PARTS & SERVICE NEWS

AA00204

SUBJECT: JOYSTICK STEERING WIRING HARNESS

APPLICATION: WA600-3L Wheel Loader Serial Numbers A52001 through A52155

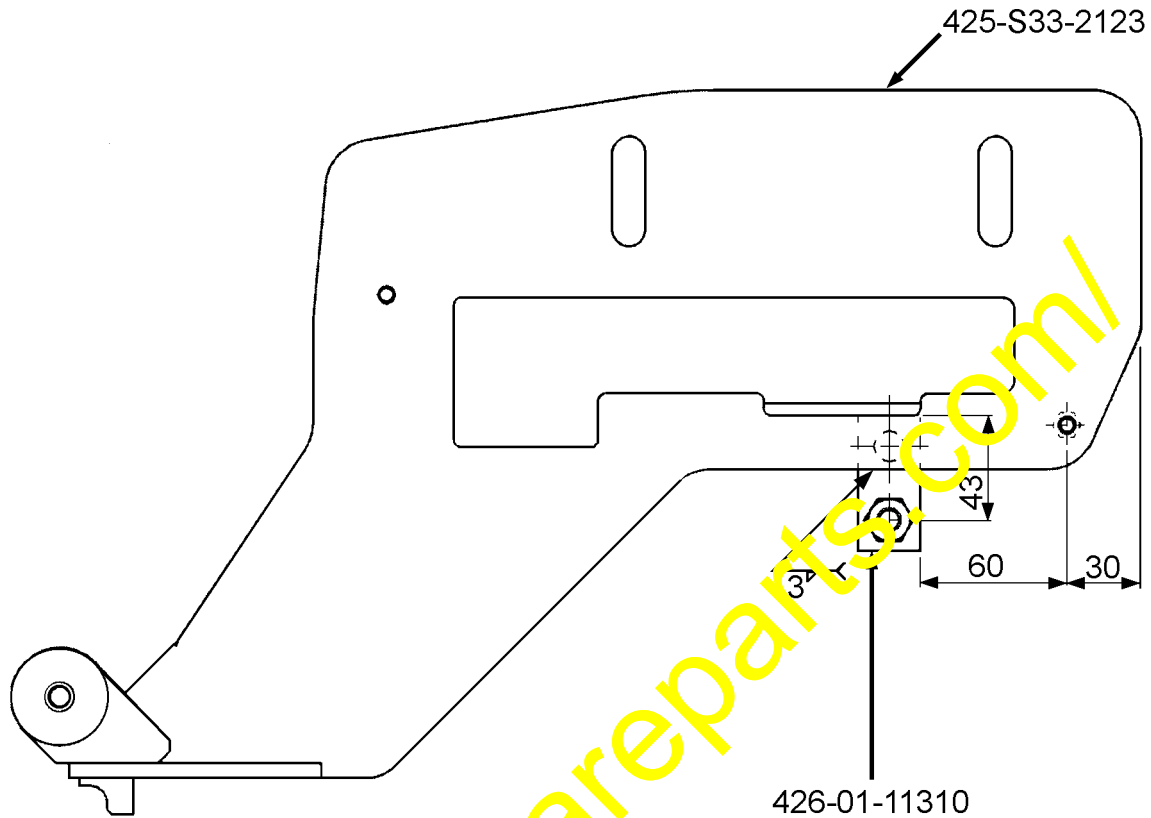
1. Slide J/S Console unit and operator seat forward as far as possible.
2. Remove screws 01023-20612 (#28) and take off cover 428-S33-2280 (#27) as shown.

3. Install the following parts:

Part No.	Description	Qty.
426-01-11310	Bracket	1
01010-81010	Bolt	1
08036-08101	Clip	1
1400072H1	Paint	1

VLPS0054

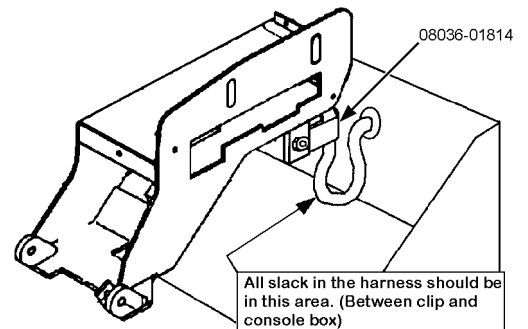
4. Weld bracket 426-01-11310 to the console as shown.

VLPS0055

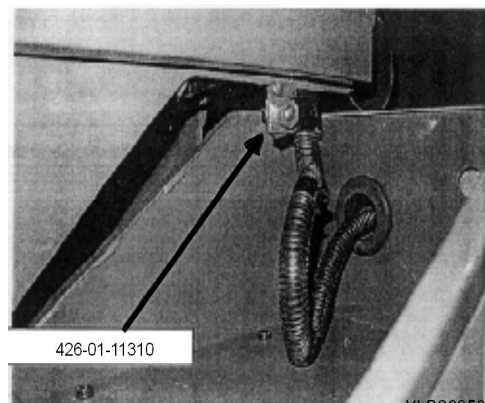
5. Paint bracket 426-01-11310 to match the console.
6. Attach clip 08036-01814 to the J/S harness.
7. Use bolt 01010-81016 to attach the clip to the new bracket. When tightening bolt be sure the harness slack is toward the rear of the cab, not between the clip and J/S console.
